SOUTHERN BOUNDARY FOR PROPOSED R1 GENERAL RESIDENTIAL ZONE

The Planning Proposal seeks to rezone the northern part of Lot 9 DP 836850 from E4 Environmental Living to R1 General Residential. The following considers the location of the southern boundary for the proposed R1 zone on Lot 9.

Figure 2: View of Lot 9 DP 836850, from Apex Lookout, Drummond Park (Focal length of 38.2mm)

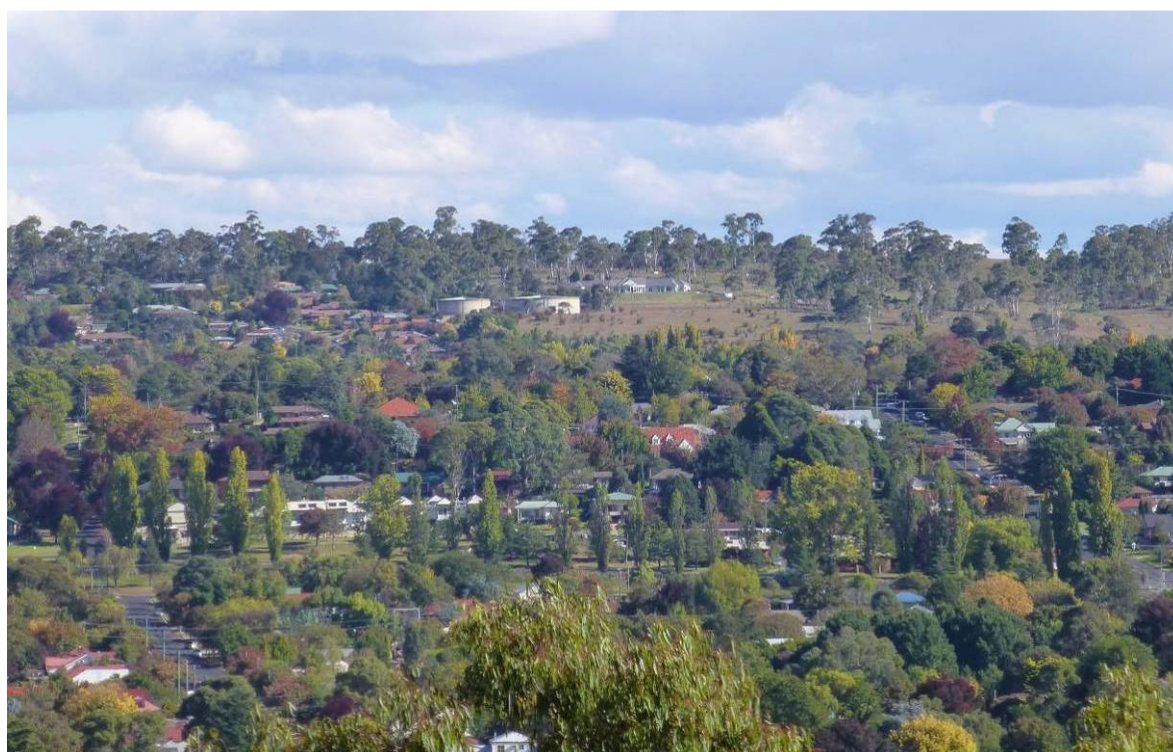
The Planning Proposal includes a Scenic Quality/Visual Impact Analysis (Attachment 3 of the Planning Proposal) prepared by All About Planning. The Analysis includes photographs of views towards Lot 9 from various vantage points around Armidale. A view of Lot 9 from Apex Lookout, Drummond Park, is shown in Figure 2.

The eastern portion of Lot 9 is relatively well screened by existing development and trees in the foreground when seen from vantage points in Armidale. However, the western portion is more visually exposed when viewed from these vantage points and it is considered that the preferred outcome is one where the visual impact of future residential development is minimised for the western portion of Lot 9.

Taking the above matters into consideration it is recommended that the R1 zone boundary follow the RL1080 contour, rather than a line approximation of the contour.
